**SunEdison Response to Site Plan Review Application Comments:
Technical Assistance Group (TAG)'s 9/12/2016 Comments
Titcomb Landfill Solar Project, 23 South Martin Road
- Submitted to Planning Board on 10/11/2016 -**

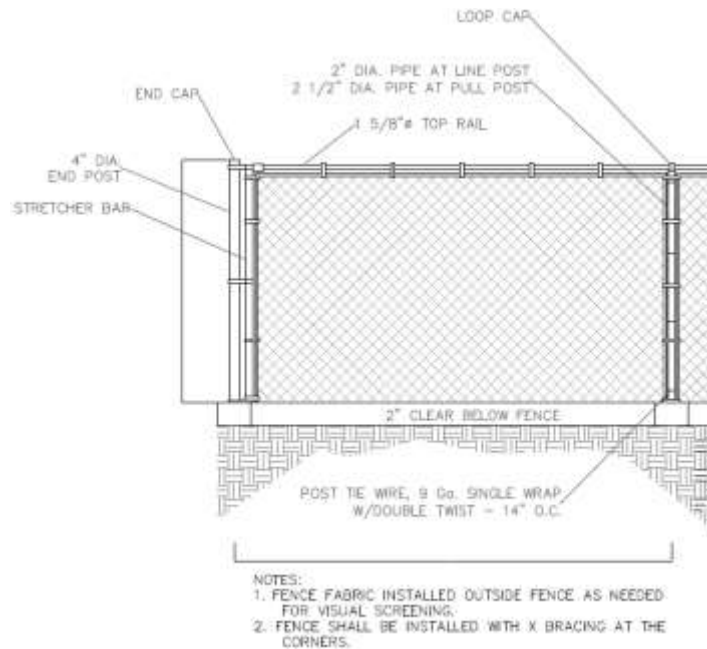
Note that the visual simulations did not include fence fabric, as we generally do not include it on most projects. The applicant included the following fence detail in the site plan (ATTACHMENT 1, sheet C-6.2):

Based on recent and ongoing correspondence with a landowner adjacent to the Titcomb Landfill, SunEdison is willing to install slats or fabric on the fence on the west side of the array (adjacent to South Martin Road) to provide additional visual screening. SunEdison is continuing discussions with the abutter to see if there are any other measures that can be taken to alleviate his concerns. Any additional measures proposed would be in line with the landfill's permit requirement to use only low-growing (shallow-rooted) vegetation in order to maintain the integrity of the cap.
